COUNTY OF VENTURA PUBLIC WORKS AGENCY WATERSHED PROTECTION DISTRICT ZONE 2 "J" STREET DRAIN IMPROVEMENT ORMOND BEACH LAGOON TO DOWNSTREAM OF HUENEME ROAD IN THE CITY OF OXNARD

SAVE DATE: 5/21/13 DOKTORN K:\PC\PROJECTS\82322 J STREET DRAIN IMPROVEMENT\FINAL DESIGN\DESIGN DRAWINGS\100%ADDENDA\ADDENDUM NO. 1\JSD-01-GP.DWG

"J" STREET DRAIN IMPROVEMENT
ORMOND BEACH LAGOON TO
DOWNSTREAM OF HUENEME ROAD
GENERAL PLAN

SHEET 7D
OF 31
DRAWING NO.
Y-2-3711D

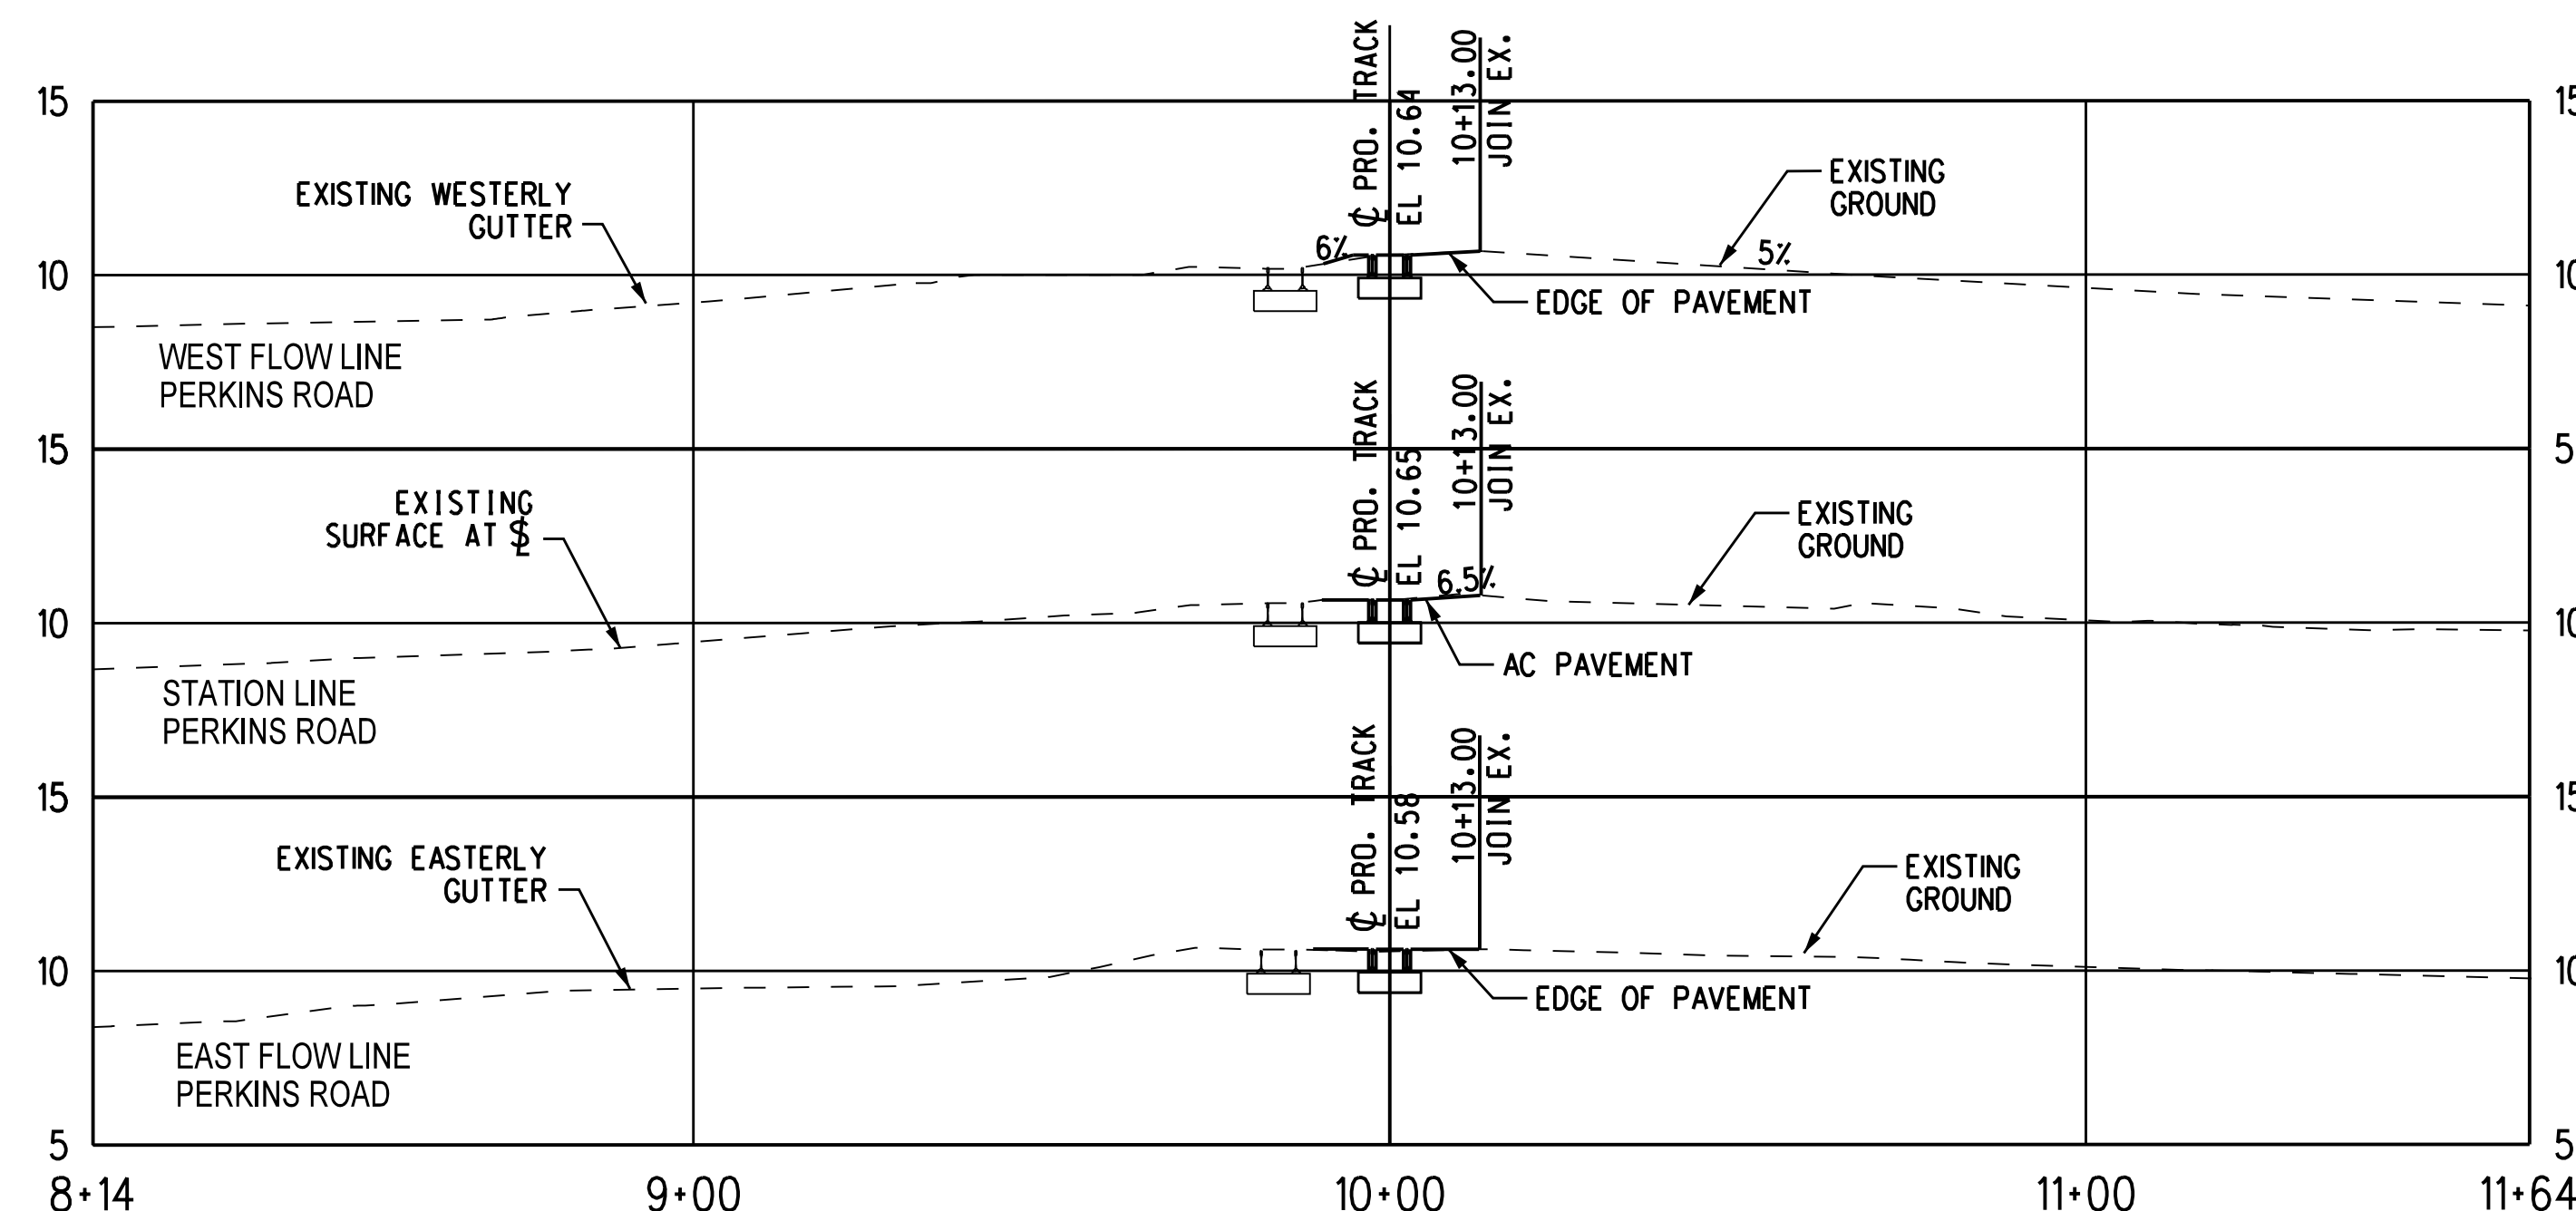
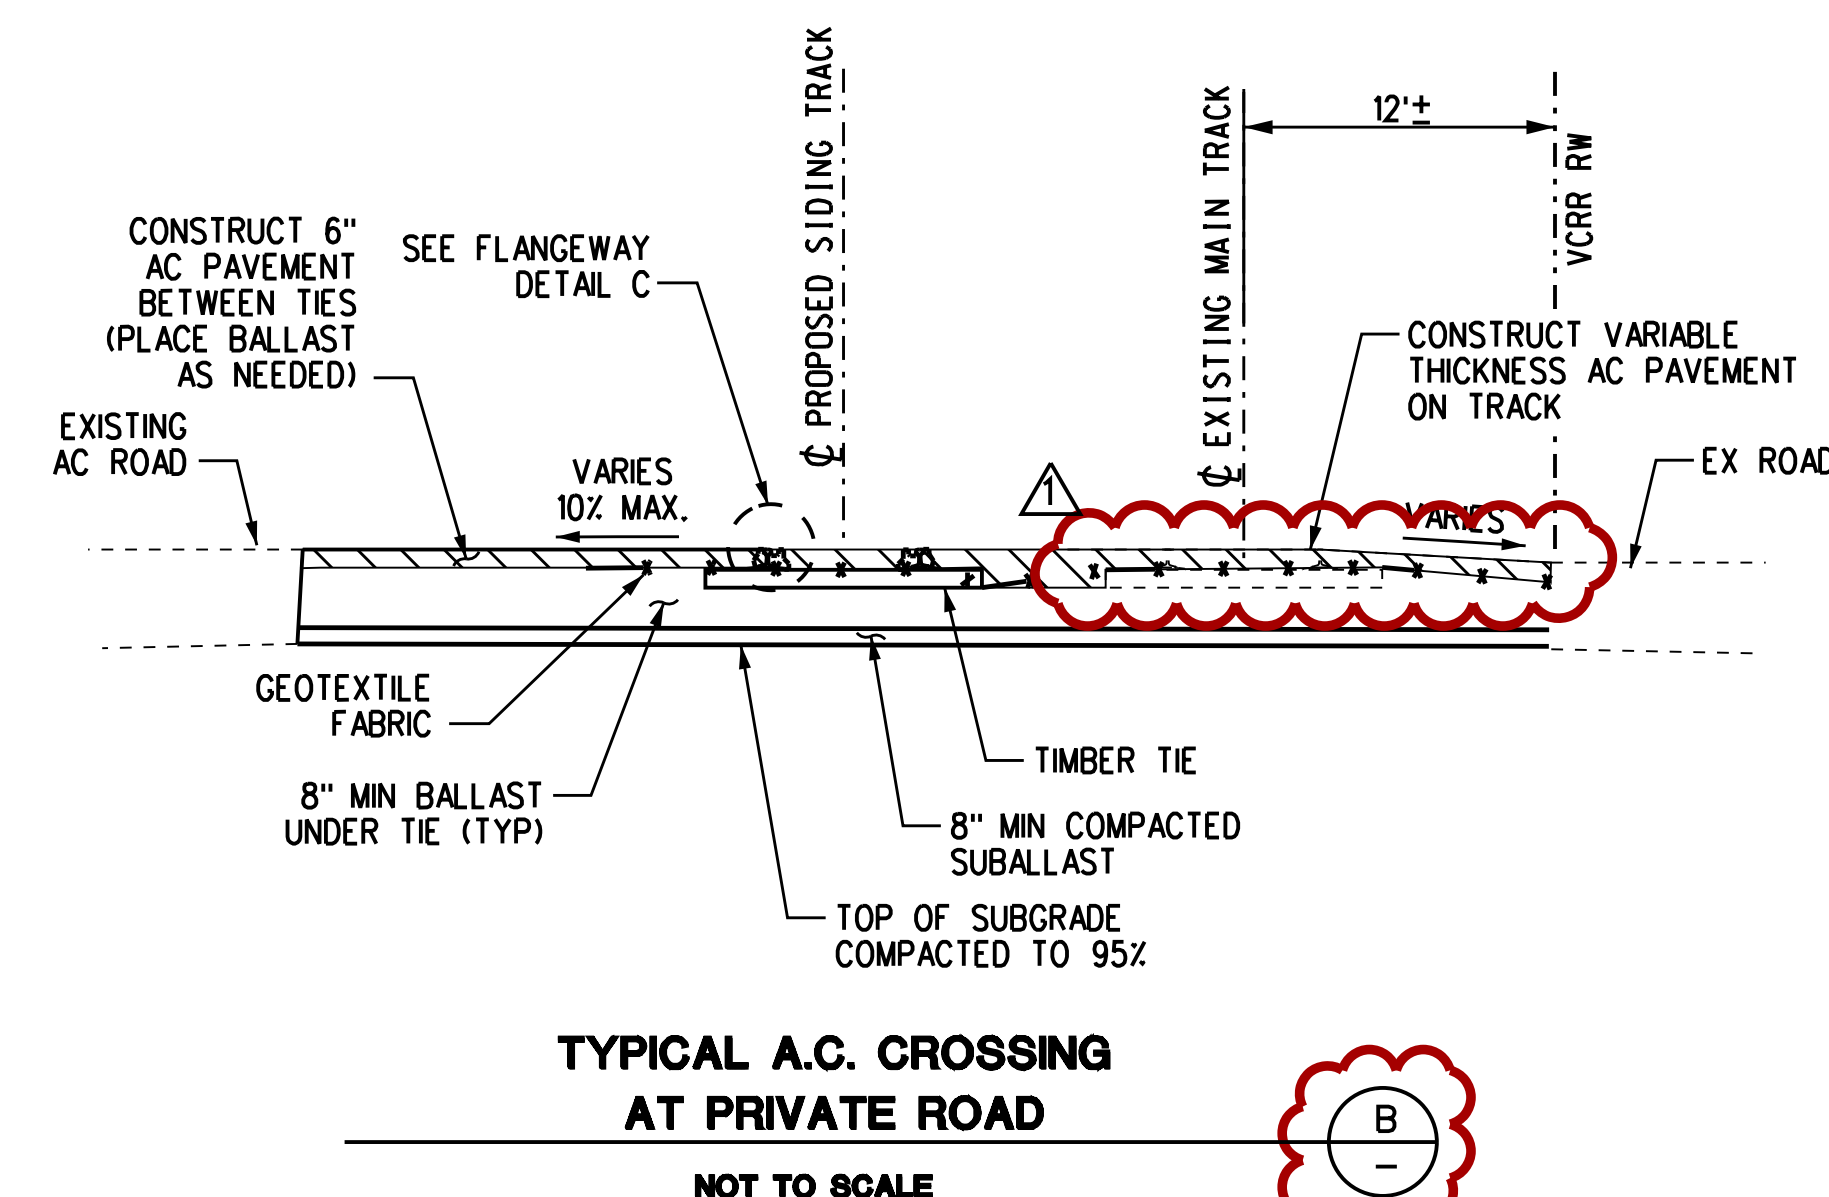
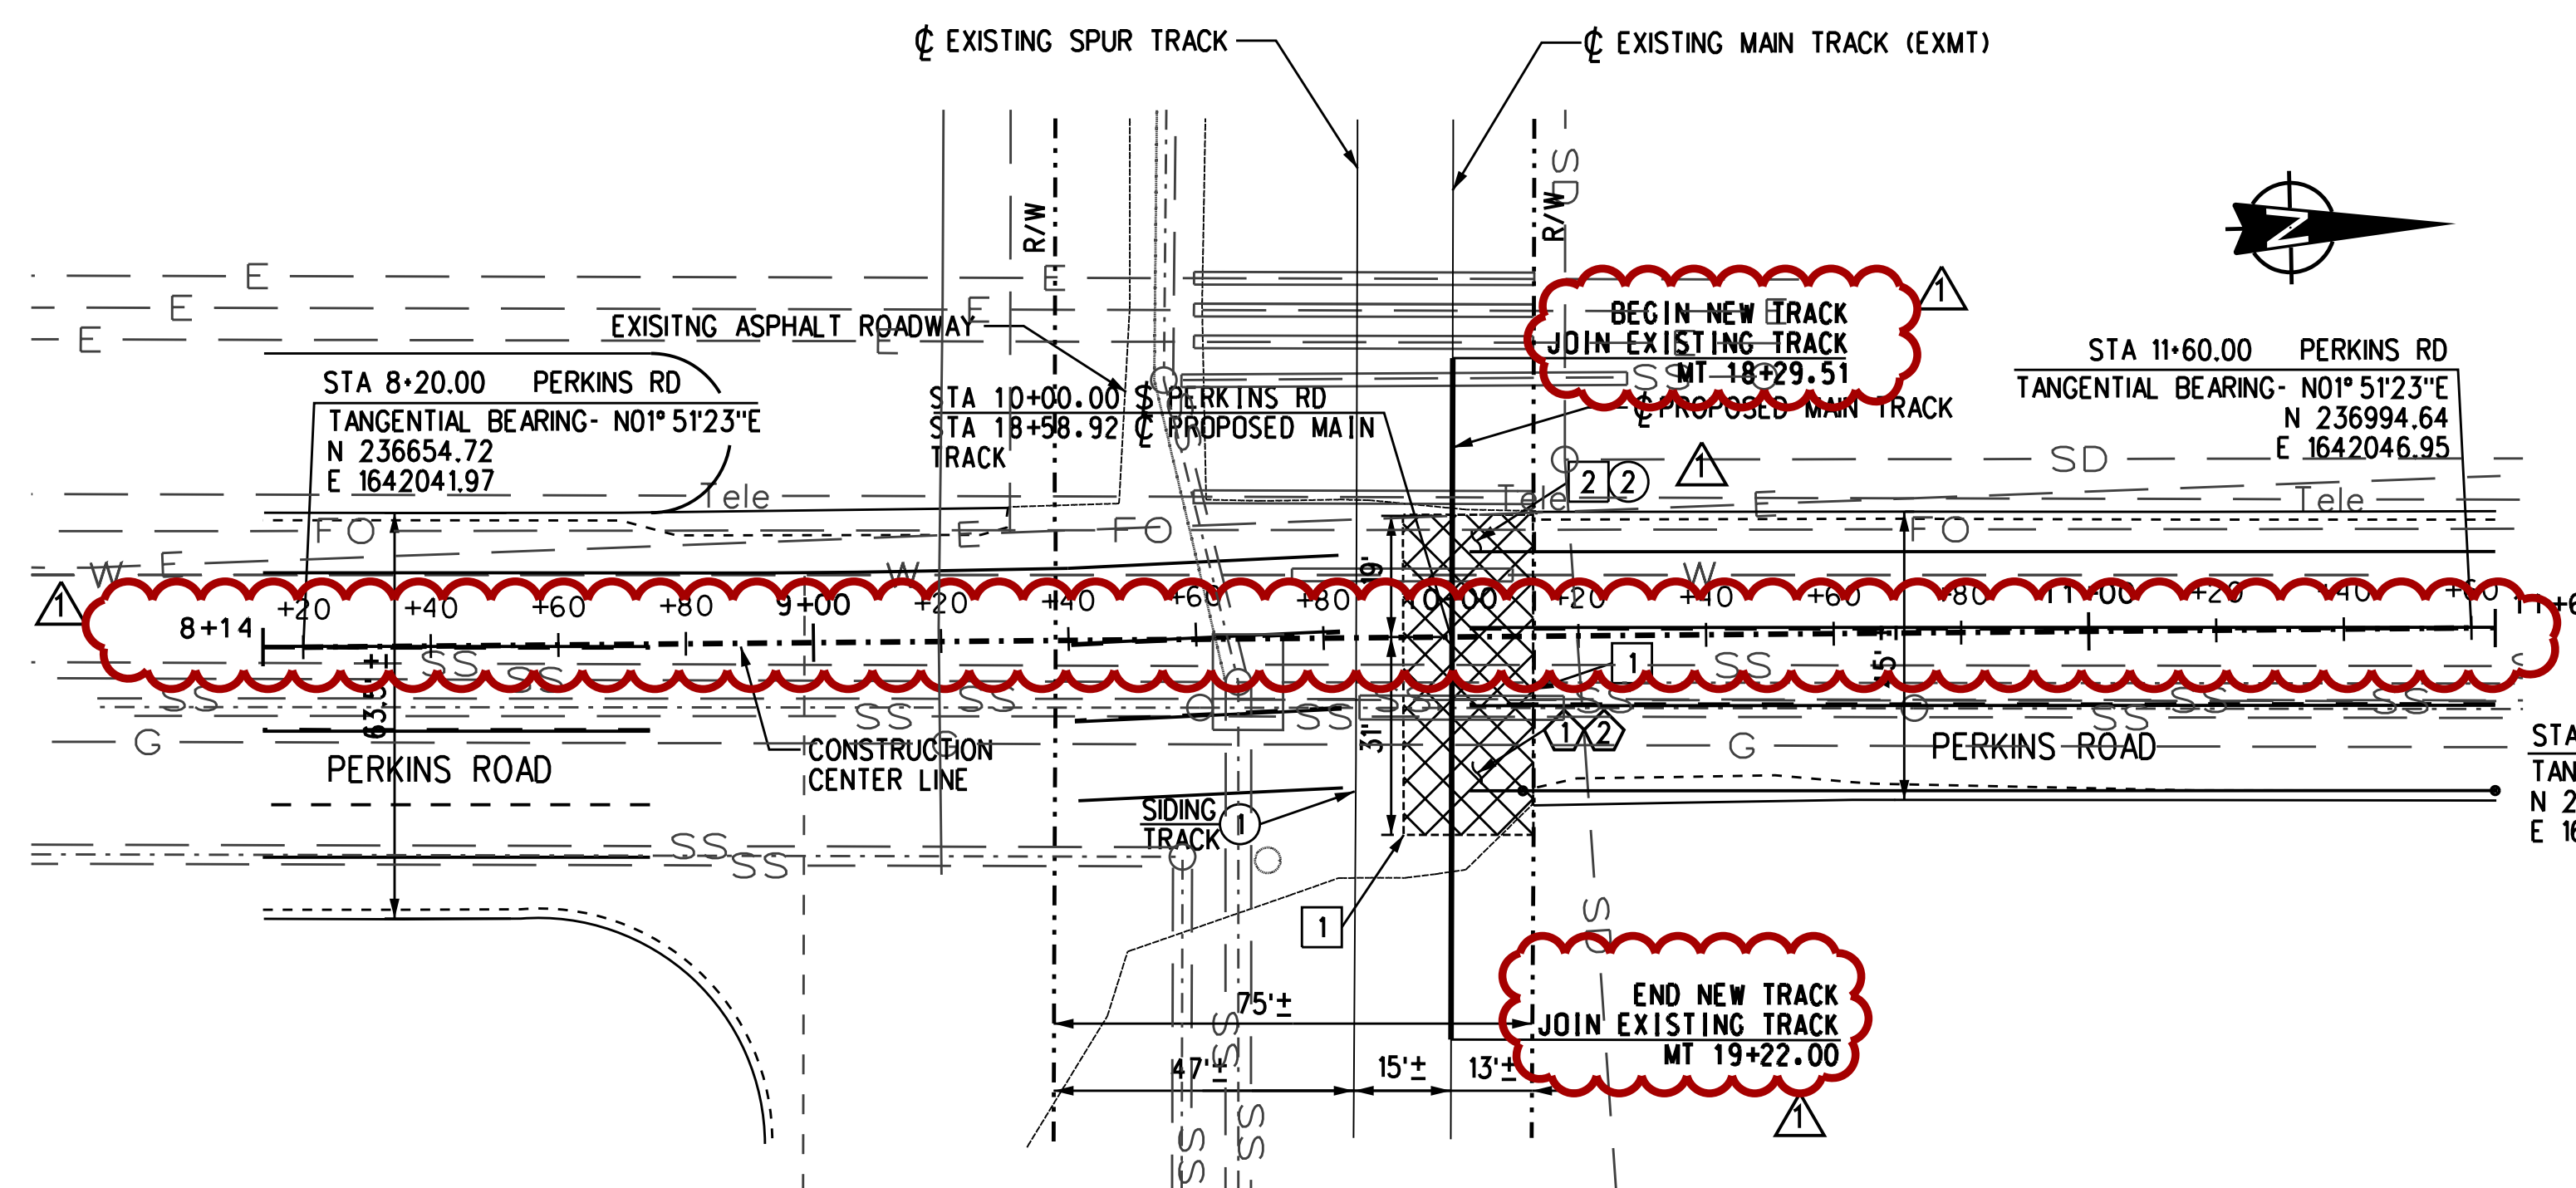
D					
C					
B					
Δ	REVISE DETAIL AND CALL OUTS	EML	06/21/13	APPROVED:	DATE
Δ	REVISION DESCRIPTION	APP.	DATE	PORT OF HUENEME, OXNARD HARBOR DISTRICT
